DATE ISSUED: November 13, 2012 **REPORT NO. PC-12-114**

SUBJECT: Appeal of the Civic San Diego Board of Directors' October 17, 2012 Approval of Centre City Planned Development Permit 2011-42 for the Palatine Project (north side of Elm Street between Columbia and State streets) – Little Italy Neighborhood of the Downtown Community Plan Area – **PROCESS THREE**

Issue(s): “Should the Planning Commission (“Commission”) uphold the Civic San Diego (“CivicSD”) Board of Director's ("Board") decision to approve Centre City Planned Development Permit (CCPDP) 2011-42 for the Palatine project ("Project") located in the Little Italy Neighborhood of the Downtown Community Plan Area?”

ELM STREET SIDEWALK
 PEDESTRIAN EXPERIENCE A3.15

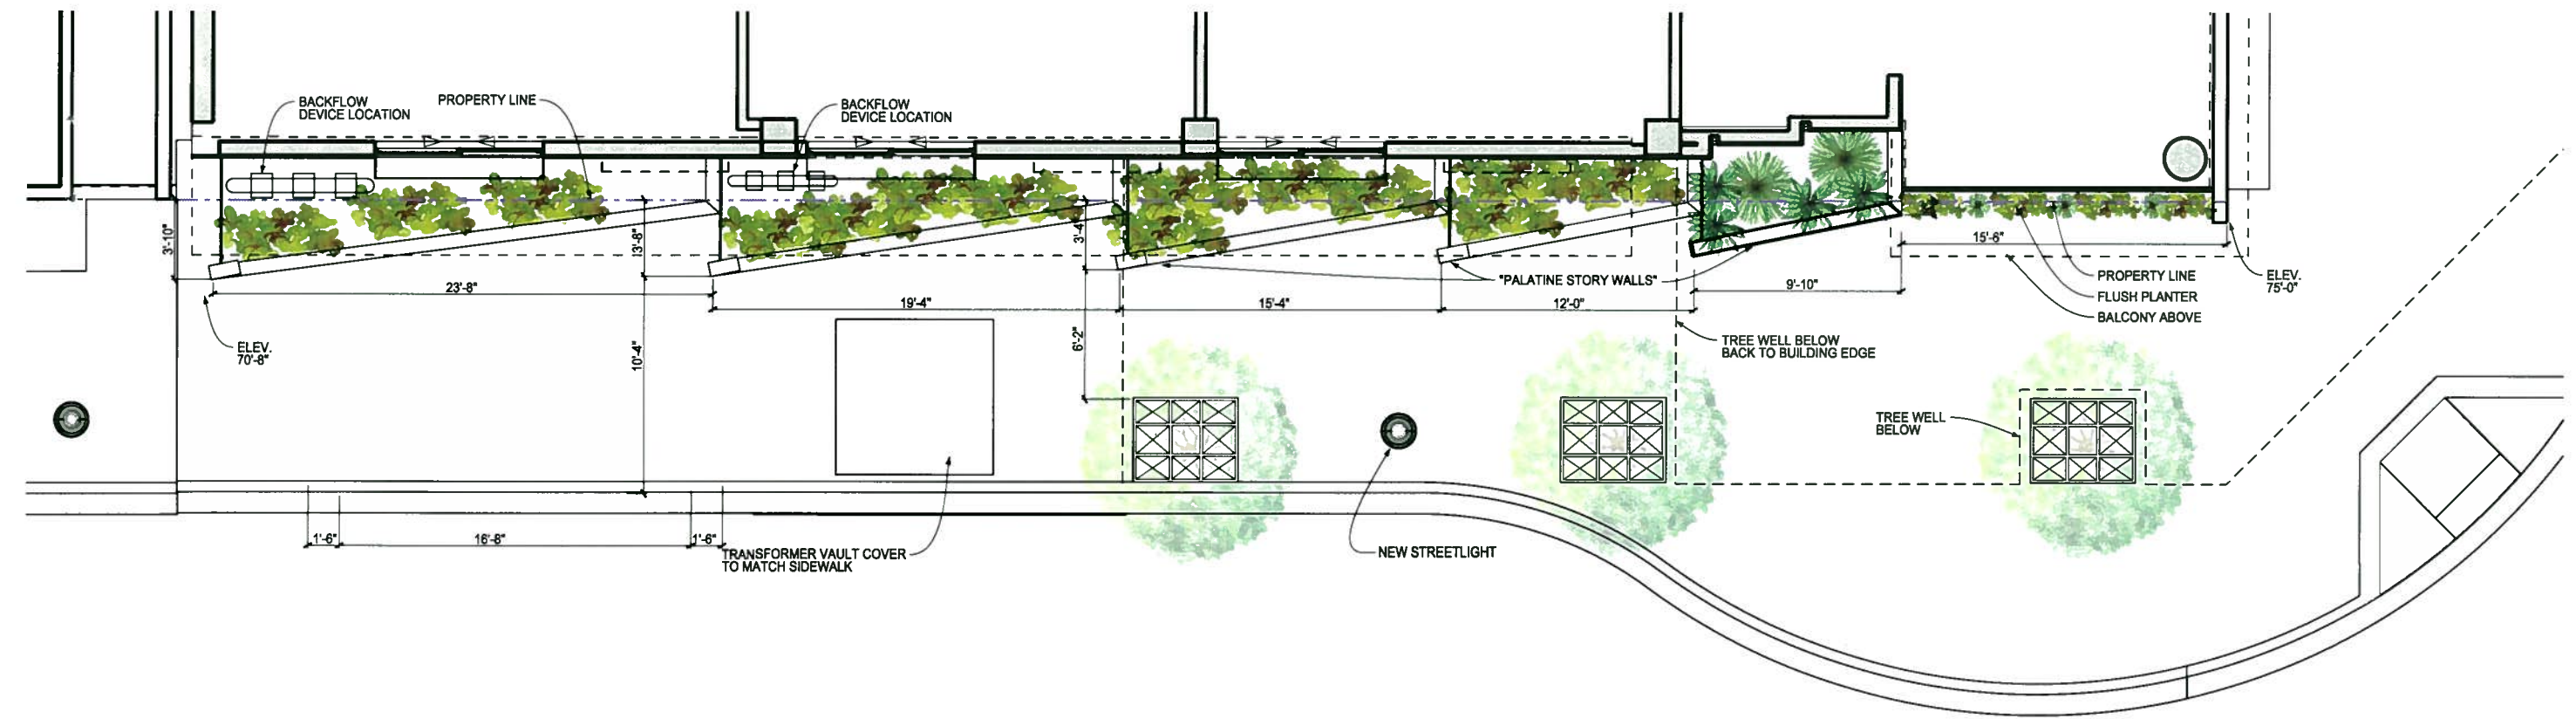
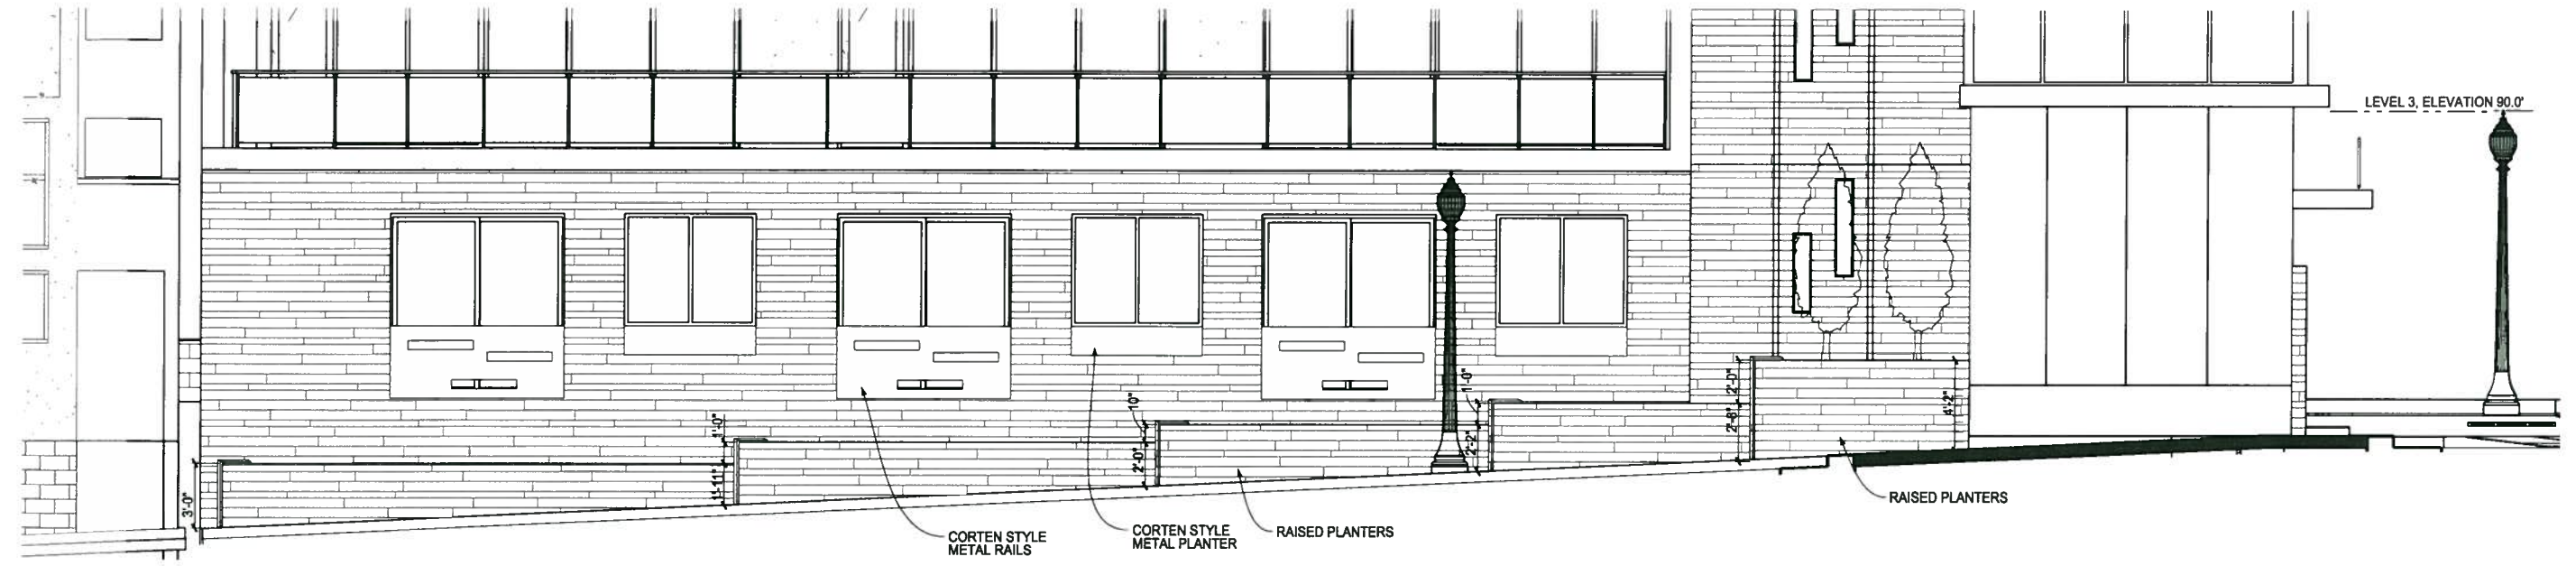
3. RAISED PLANTERS IN THE RIGHT OF WAY: ON ELM STREET, IN ORDER TO ENRICH THE PEDESTRIAN EXPERIENCE, LOCATE THE BACKFLOW DEVICES, AND ALLOW PLANTING TO GROW ON LEVEL GROUND, WE PROPOSE PROVIDING STEPPED PLANTERS AS SHOWN ON SHEET A3.15

MINIMUM STREET WALL HEIGHT

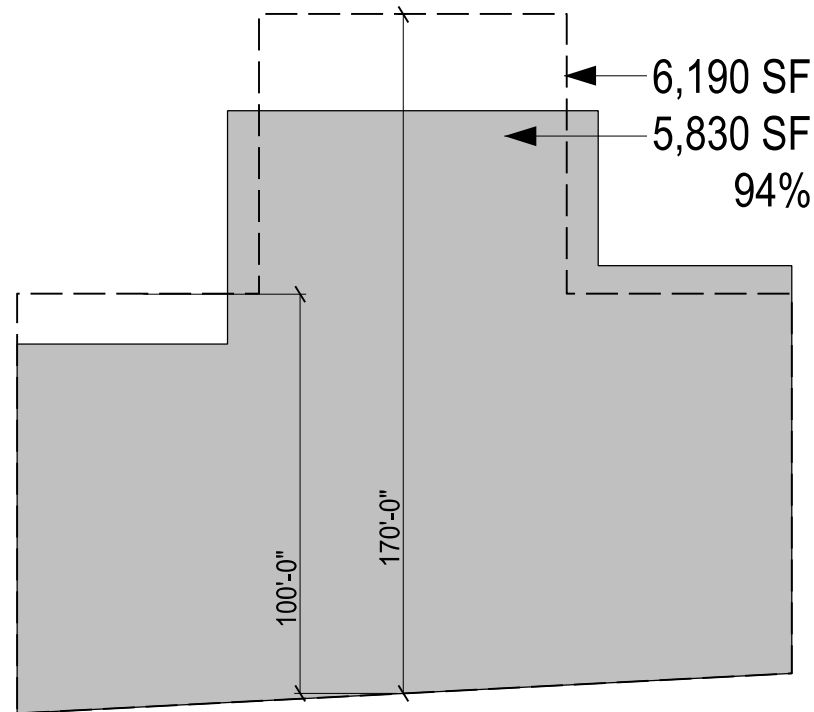
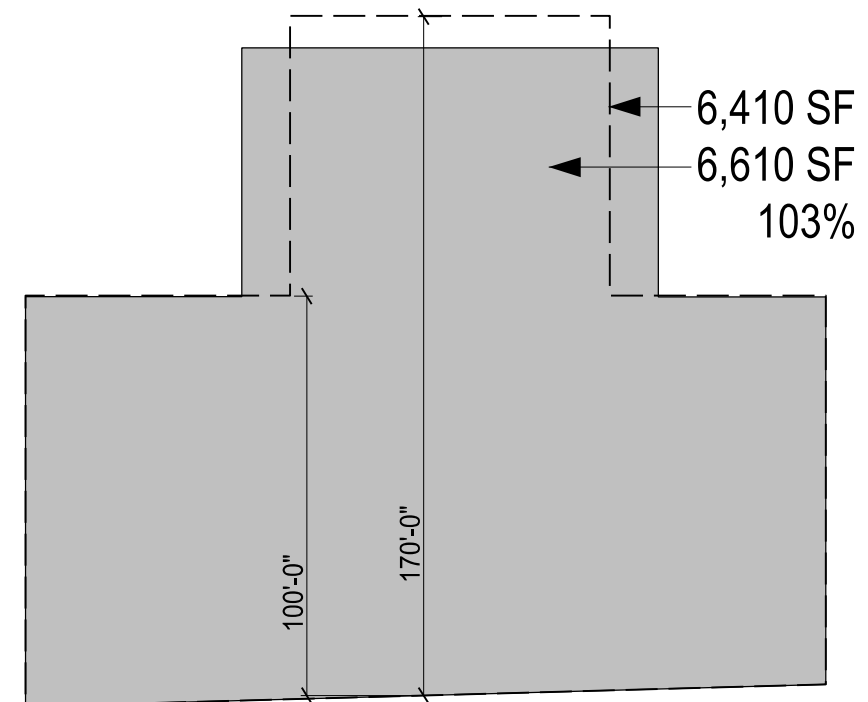
2. Street Wall Height – The CCPDO requires the street wall height for the Project to be a minimum of 40 feet along 100 percent of the total street frontage, with certain exceptions. The Project does not qualify for any of the exceptions under the CCPDO and is, therefore, requesting a deviation to allow the Project's street wall height to be reduced to 12 feet along 40 percent of the Columbia Street frontage in order to provide light and views into the interior courtyard facing units.
